Access Compliance Report Public Rights-of-Way (Curb Ramps)

Main Street: OLYMPIA_WAY Cross Street: FAIRHAVEN_AVE Location: NE

ADA ID: RPAT211022090534 Ramp Type: Type 4 - Parallel Initial Pass/Fail: Fail Overall Compliance: No Severity Score: 2

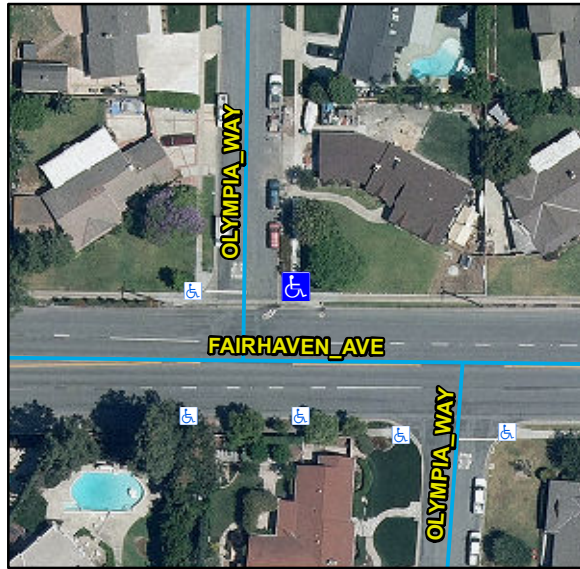
Compliance	Description	Data	Compliance	Description	Data
N/A	Ramp Length LT (in)	115	N/A	Ramp Length RT (in)	125
Yes	Ramp Width LT (in)	58	Yes	Ramp Width RT (in)	62
Yes	Ramp Run Slope LT (%)	4.8	Yes	Ramp Run Slope RT (%)	7
No	Ramp Cross Slope LT (%)	3.5	No	Ramp Cross Slope RT (%)	4.1
N/A	Landing Present	N/A	N/A	DWS Provided	N/A
N/A	Landing Length (in)	N/A	N/A	DWS Contrast	N/A
N/A	Landing Width (in)	N/A	N/A	DWS Length (in)	N/A
N/A	Landing Run Slope (%)	N/A	N/A	DWS Full Width	N/A
N/A	Landing Cross Slope (%)	N/A		DWS Offset Type	N/A
N/A	Landing Movement Obstructed?	N/A	N/A	DWS Offset Left (in)	N/A
	Landing Movement Type	N/A	N/A	DWS Offset Right (in)	N/A
N/A	Landing Shared	N/A			
N/A	Clear Space	Yes			
N/A	Clear Space To Crosswalk (in)	N/A			
N/A	Marked Crosswalk 1	No	N/A	Marked Crosswalk 2	No
	Crossing 1 Direction	W		Crossing 2 Direction	S
	Marked Crosswalk 1 Width (in)	N/A		Marked Crosswalk 2 Width (in)	N/A
N/A	Ramp Inside Crosswalk 1	N/A	N/A	Ramp Inside Crosswalk 2	N/A

Crossing 1 Slope (%)	4.4		Crossing 2 Slope (%)	5.7
	Crossing 1 Cross Slope (%)	2.5		Crossing 2 Cross Slope (%)	1.2
N/A	Gutter Ponding	N/A	N/A	Curb Slope	5.7
Yes	Gutter Lip Height (in)	0		Road Run Slope (%)	1.7
N/A	Gutter Run Slope (%)	N/A		Road Cross Slope (%)	5.1
N/A	Gutter Cross Slope (%)	N/A	Yes	Perpendicular Joint Present	Yes
Yes	Overall Surface Condition	Acceptable			
	Cross Gutter Present?	Yes		Spandrel Present?	Yes
	Replace Cross Gutter?	No		Replace Spandrel?	No

Remove & Replace Curb Ramp With Two New Directional Ramps or Equivalent.

R304.5.3, STD 1115
